# MONITORING YEAR 3 ANNUAL REPORT

## HENRY FORK MITIGATION SITE

Catawba County, NC  
DEQ Contract No. 005782  
DMS Project No. 96306

RE: **Response to MY3 Draft Report Comments  
Henry Fork Mitigation Project**  
DMS Project # 96306  
Contract Number 005782  
RFP Number 16-005298  
Catawba River Basin – CU# 03050103 Expanded Service Area  
Catawba County, North Carolina

### Recorded Stream Gage Plots

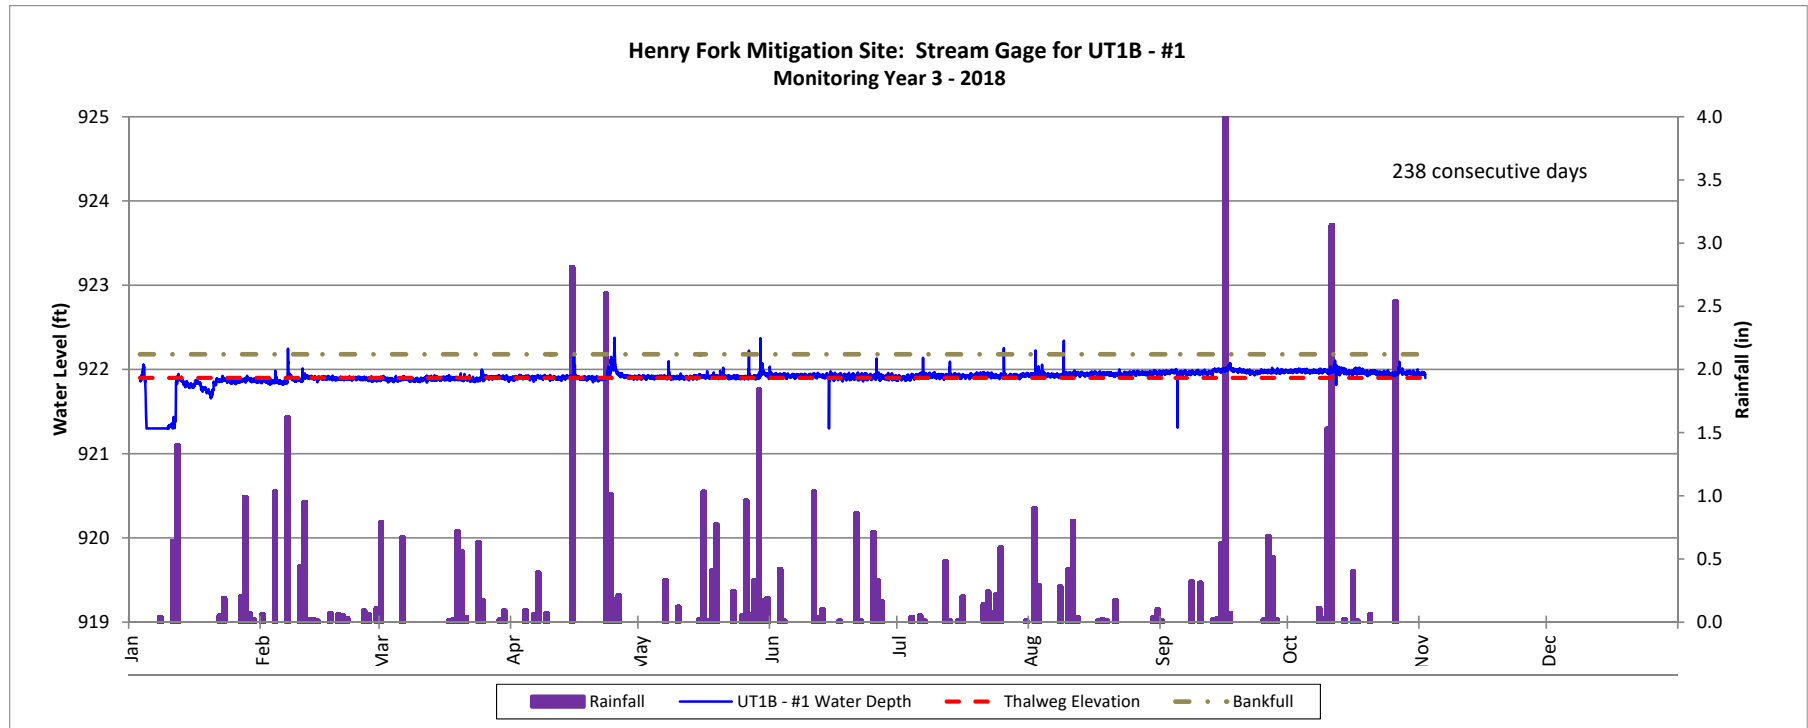
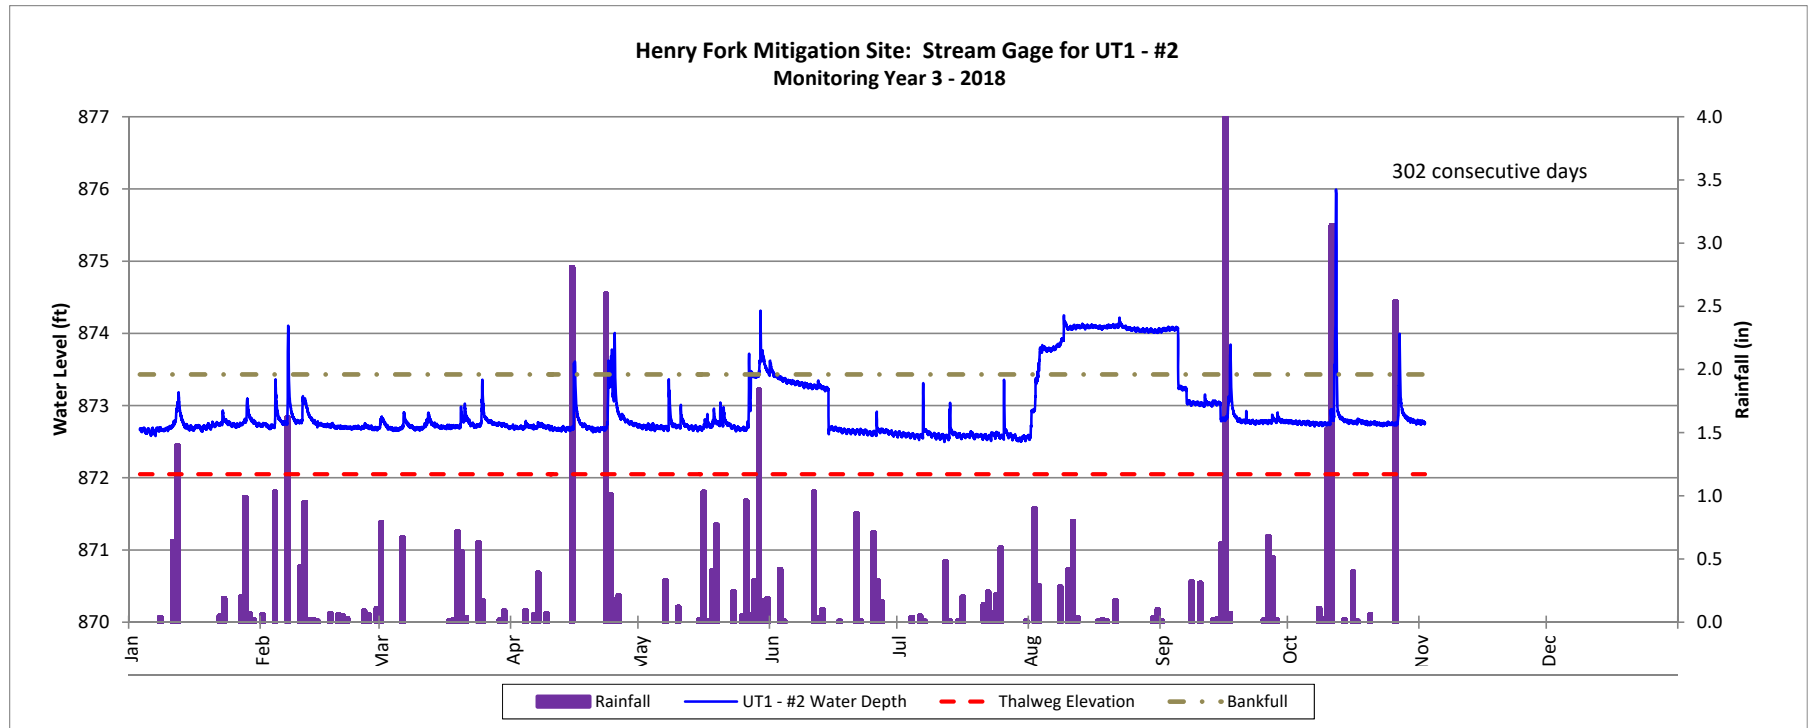
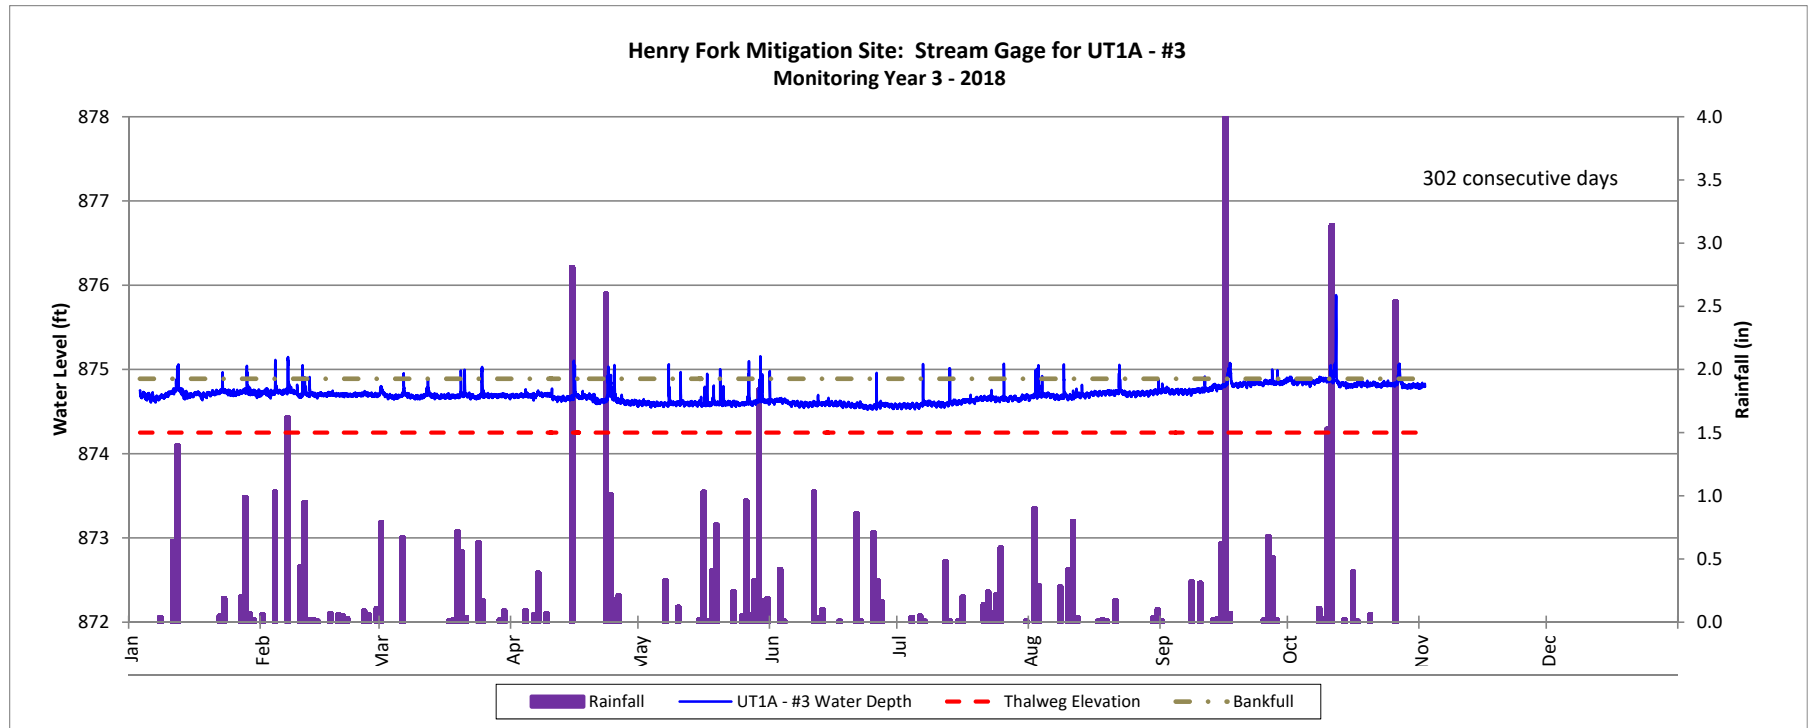
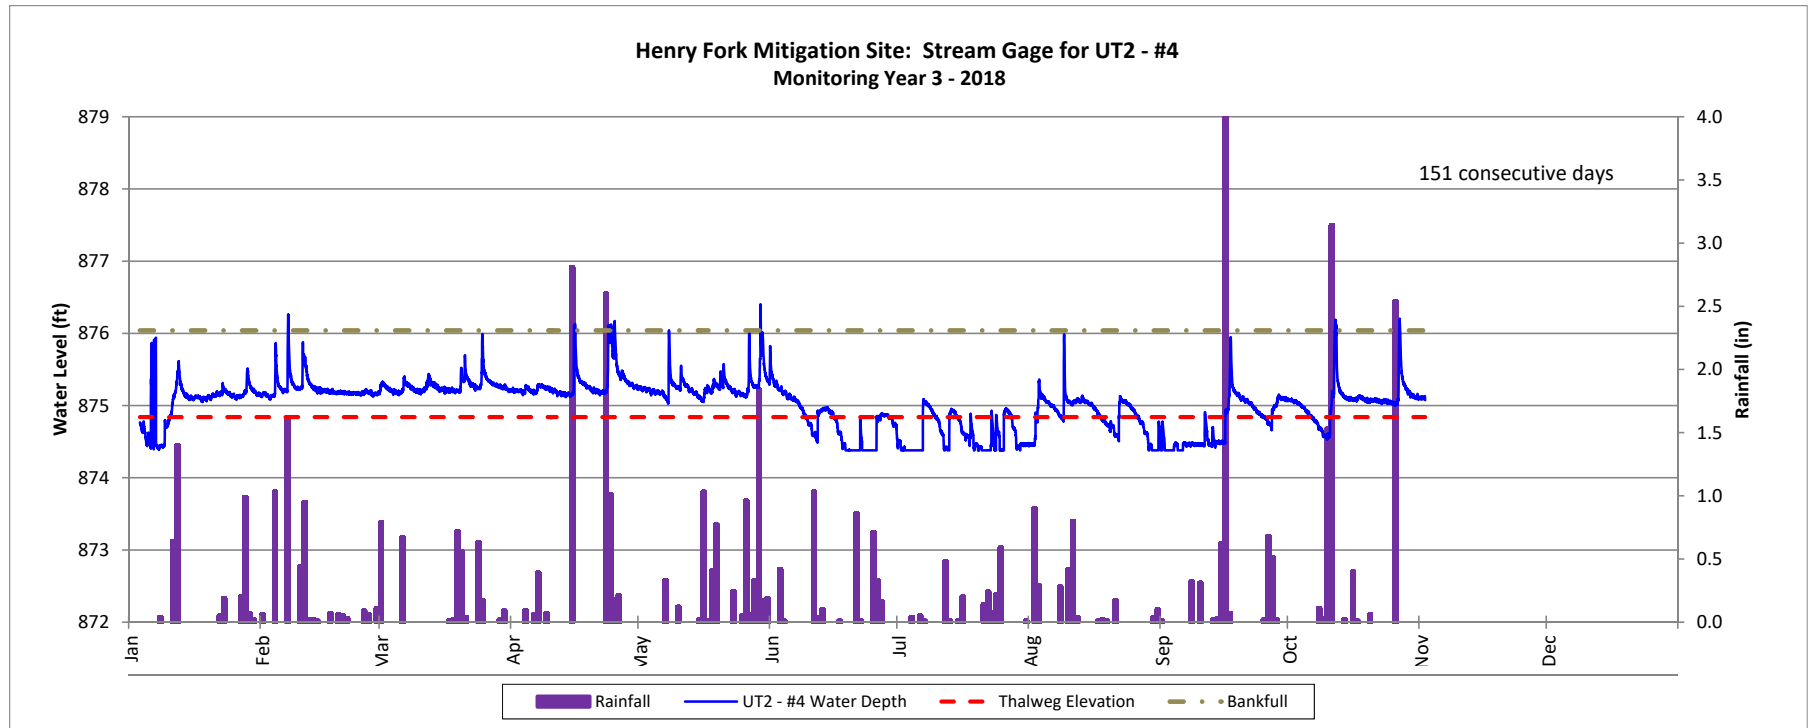
**DMS comment; Stream Gage Plots: Please add number of consecutive days to each graph or add a table similar to Table 14 to present this information.**

*Wildlands response; The stream gage plots have been updated to include the number of consecutive days of flow.*
